**Subject: Palo Verde Nuclear Generating Station (PVNGS)
Unit 2 and Unit 3, Docket Nos. STN 50-529 and STN 50-530
Core Operating Limits Report (COLR), Unit 2-Revision 8
and Unit 3-Revision 11**

PVNGS UNIT 2 CORE OPERATING LIMITS REPORT

Revision 8

Revision 11

FIGURE 3.2.4-2
DNBR MARGIN OPERATING LIMIT BASED ON
THE CORE PROTECTION CALCULATORS
(COLSS OUT OF SERVICE, CEAC's OPERABLE)

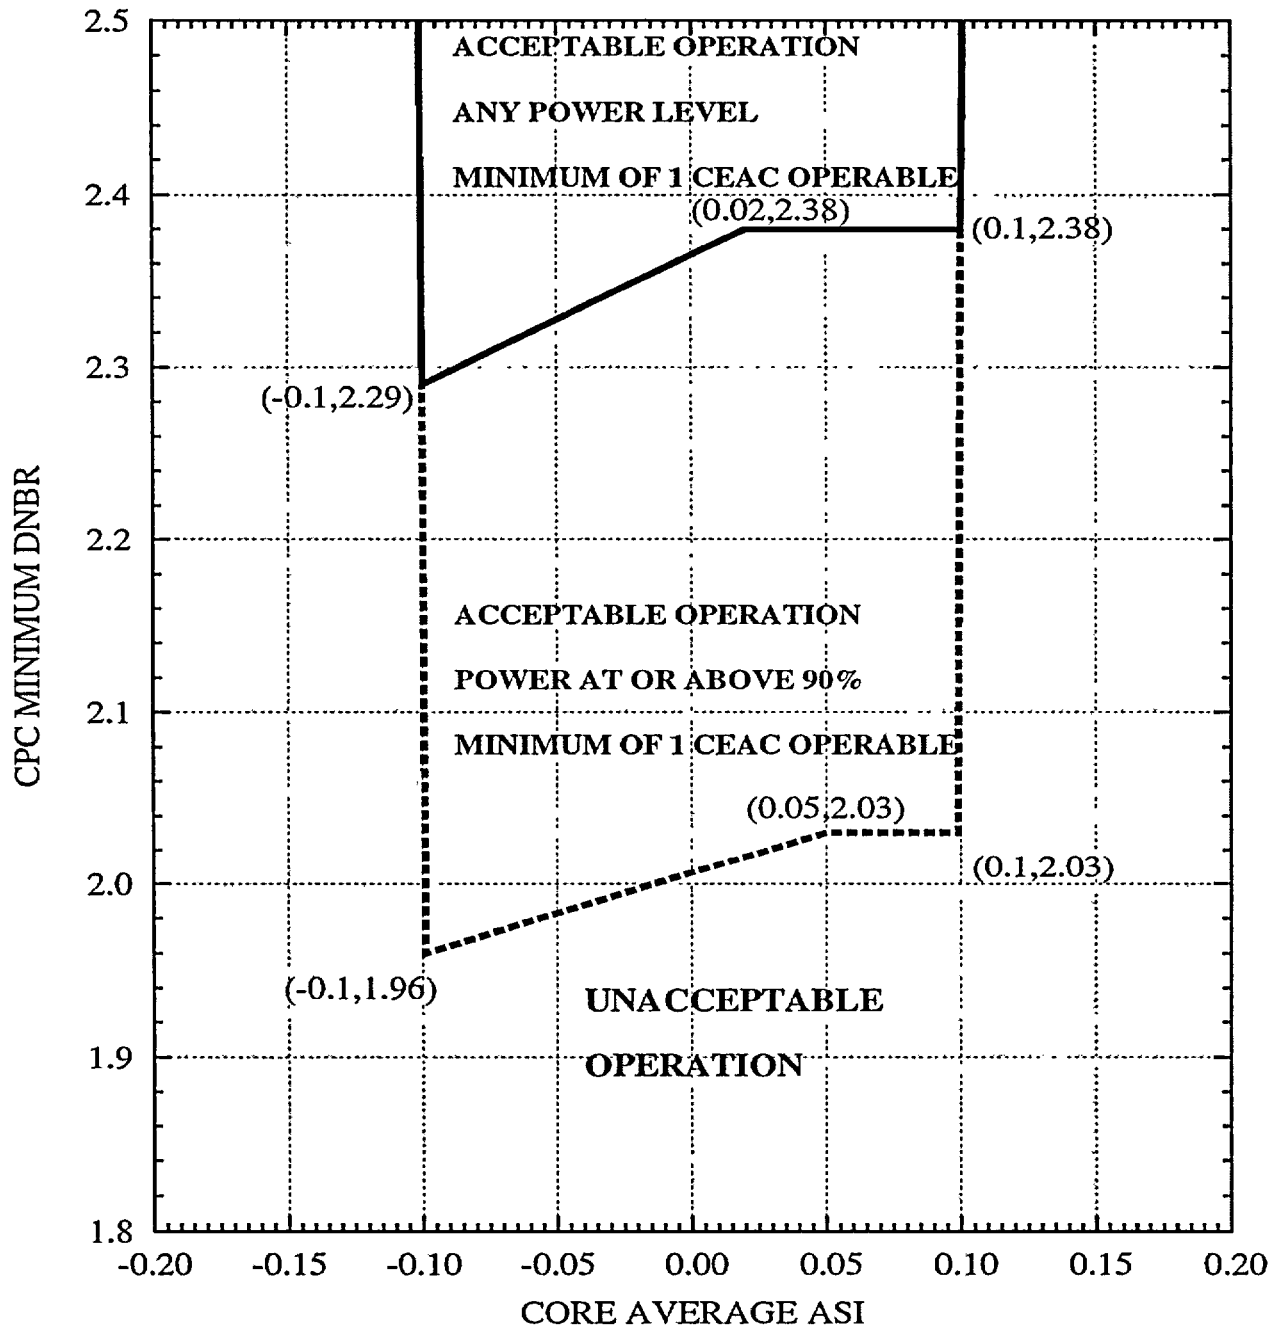
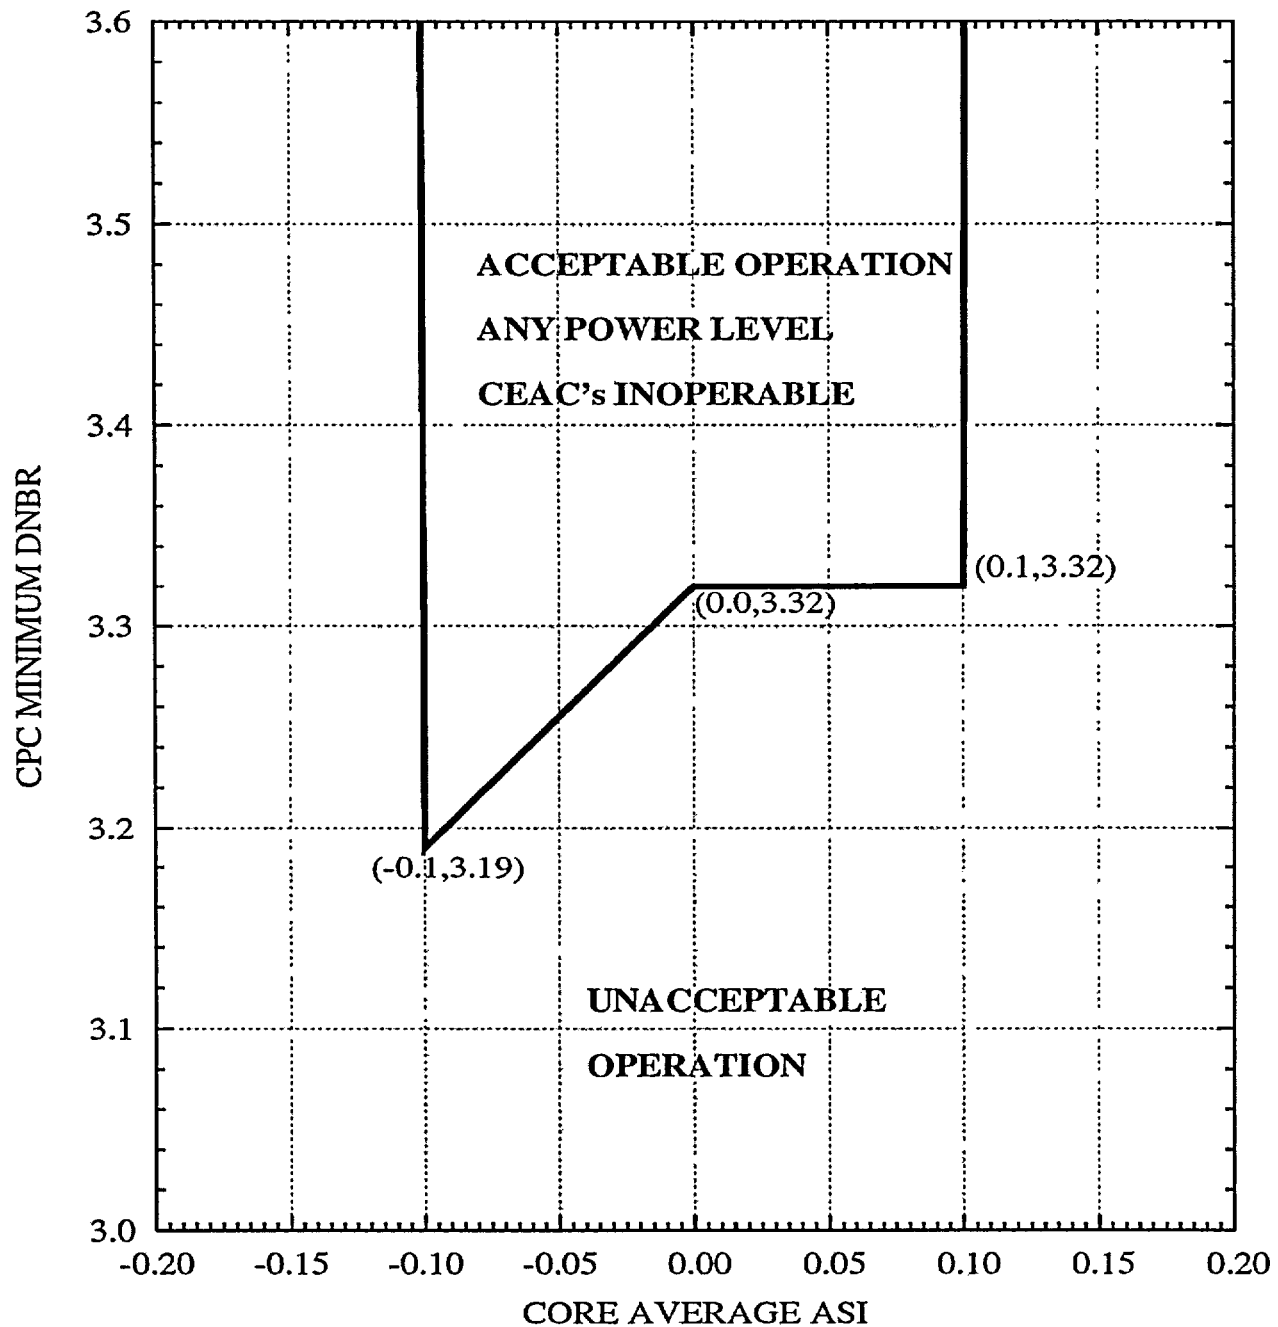
Pursuant to PVNGS Technical Specifications, Section 5.6.5.d, Arizona Public Service Company (APS) is providing the NRC with Revision 8 to the COLR for Unit 2 and Revision 11 to the COLR for Unit 3, which were made effective on April 15, 2003. The revisions to the Unit 2 and Unit 3 COLRs deleted Figure 3.2.3-1, "Azimuthal Power Tilt Versus Power (COLSS In Service)". This limit is now contained in the COLR section 3.2.3 describing the operating limit for "Azimuthal Power Tilt (T_q)". In addition, the limits associated with ASI (Axial Shape Index) in section 3.2.5 and the minimum departure from nucleate boiling ratio (DNBR) contained in Figure 3.2.4-2 "COLSS Out of Service Based on the Core Protection Calculators" were changed for the Unit 3 COLR.

COLSS OUT OF SERVICE and Either One or Both CEACs are OPERABLE - Operating within the region of acceptable operation of Figure 3.2.4-2 using any operable CPC channel.
